ADDENDUM 1
TO
Town of Rosman and City of Brevard Waterline Interconnect
DWI Project Number SRP-D-ARP-0028

This Addendum No. 1 is issued this the 10th day of September 2024 to all parties who hold a set of Bid Documents for the project entitled: "Town of Rosman and City of Brevard Waterline Interconnect" for Transylvania County. This Addendum 1 shall become part of the Contract Documents and its receipt shall be acknowledged on the bid documents at the time of bidding.

- A. See attached revised Sheets C-1 and C-4. Changes have been clouded and are described below and in other revised documents.

CONSTRUCTION PLANS FOR:

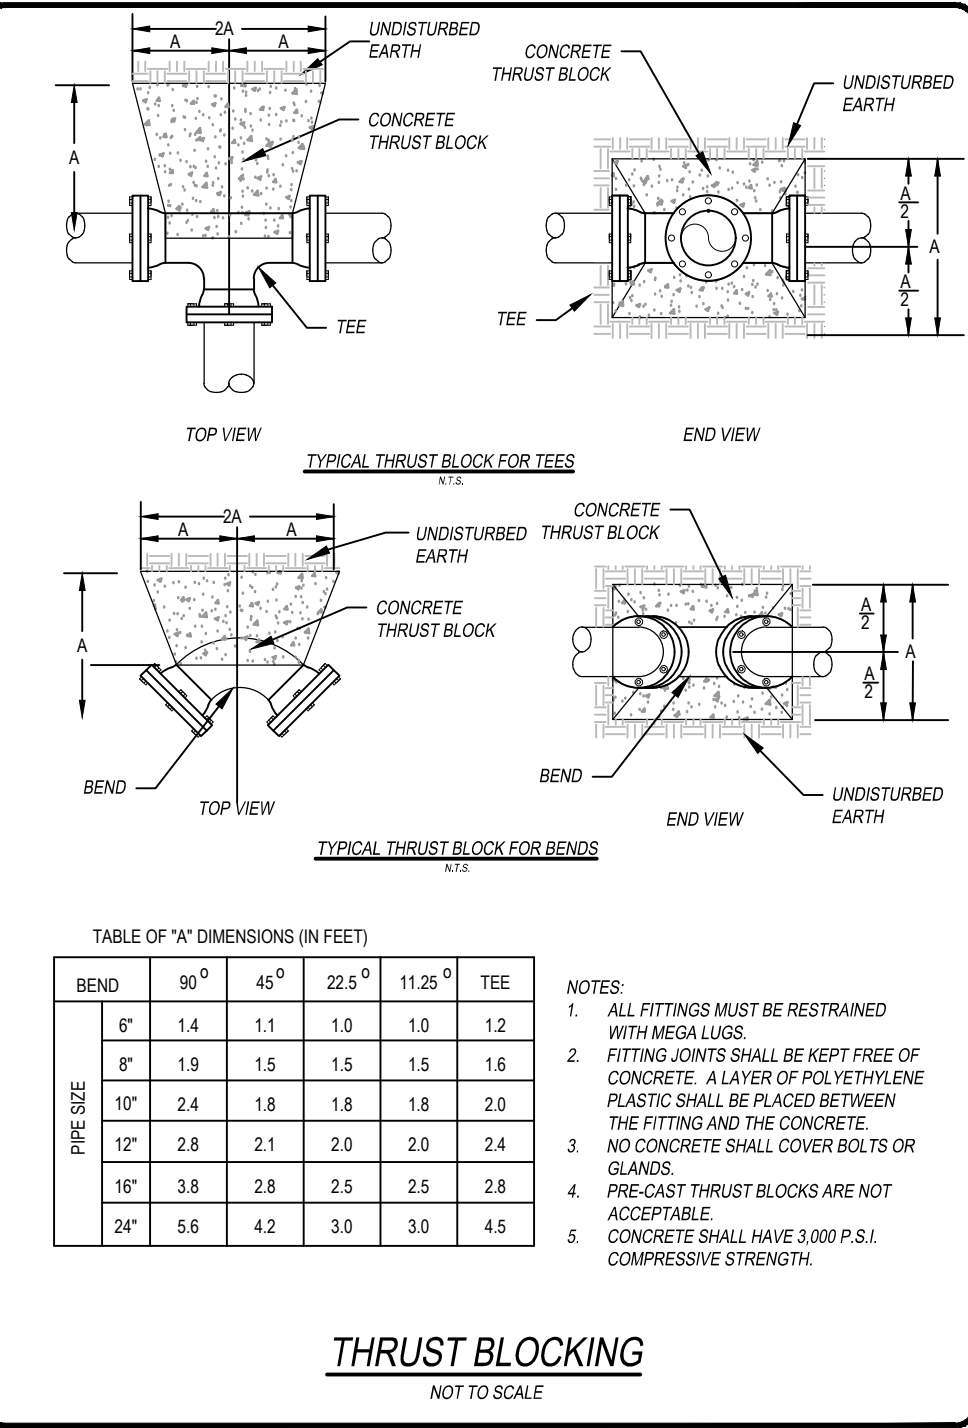
- f. Item 14 - removed "meter box" from description. ARV shall be installed in a manhole per revised detail on Sheet C-4.

- 4) Is the 2" air release to be installed in meter box or manhole?

Answer: Manhole. See revised detail on Sheet C-4.
